# IN THE MATTER OF THE APPLICATION FOR AUTHORIZATION TO INJECT, C-108, FOR THE EXXON STATE NO. 8 WELL OPERATED BY MESQUITE SWD, INC.

## RESPONSE TO REQUEST FOR ADDITIONAL INFORMATION CONCERNING THE AREA OF REVIEW

THE MESQUITE EXXON STATE NO. 8 SALTWATER DISPOSAL WELL, OTHER WELLS AND CONDITIONS in and around Section 15, Township 21 South, Range 27 East Eddy County, New Mexico

September 11, 2008

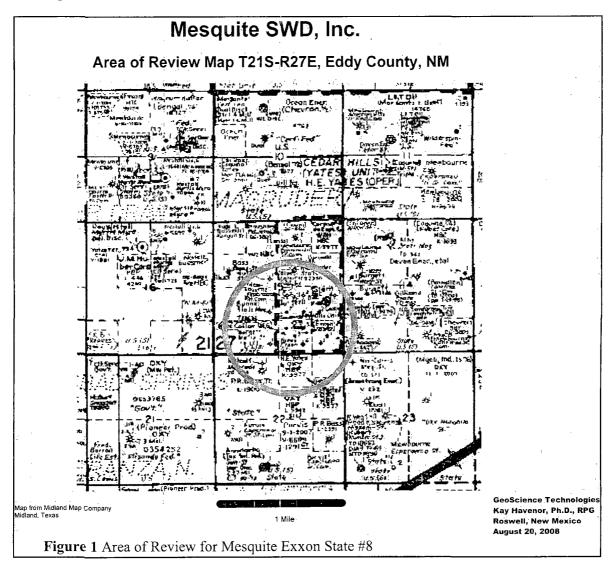
The Area of Review (AOR) land map with ½ mile radius of Area of Review shown, Figure 1, has previously been submitted with the original C-108 application. A more recent land map with AOR shown is presented here. All parties within the required area have been notified and no protests have been filed.

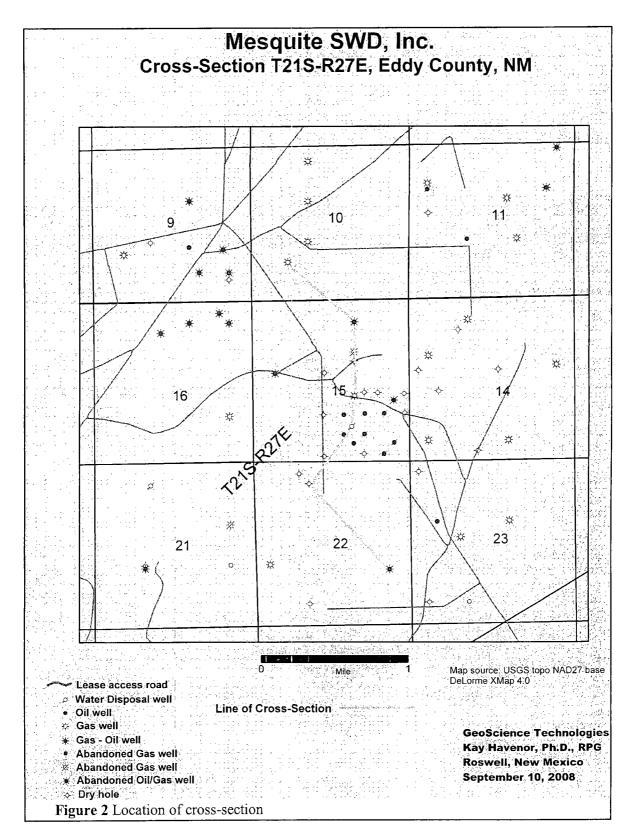
Figure 2, p. 3, illustrates the location of the cross-section requested. Figure 3, p. 4, is the cross-section that illustrates the relationship of the Exxon State #8 disposal well to the back-reef facies of the Capitan reef system.

The labels on the cross-section indicate the top of the *Seven Rivers/Capitan*. The Seven Rivers Formation is predominately dolomite that laterally transitions into massive limestone. The massive limestones deposits continue south of the cross-section area toward the organically constructed "reef" that appears to be of concern. That transition occurs at least one mile south of the southern limit of the cross-section.

Based upon the depths observed in the cross-section, the base of the Yates in the Exxon State #8 would be encountered at 802'. This is the same straight depth of the Yates encountered in the Mewbourne Oil Esperanza 14 State #2 in the SW/SW of Section 14 (not on the crosssection). The Exxon State #8 TD is 694'. A previous conservative estimate of 765' (Havenor, 2008, p. 23) to the top of the Seven Rivers/Capitan was conservative by about 37'. The base of the disposal zone in the Exxon State #8 should be considered as 107' above the base of the Yates Formation.
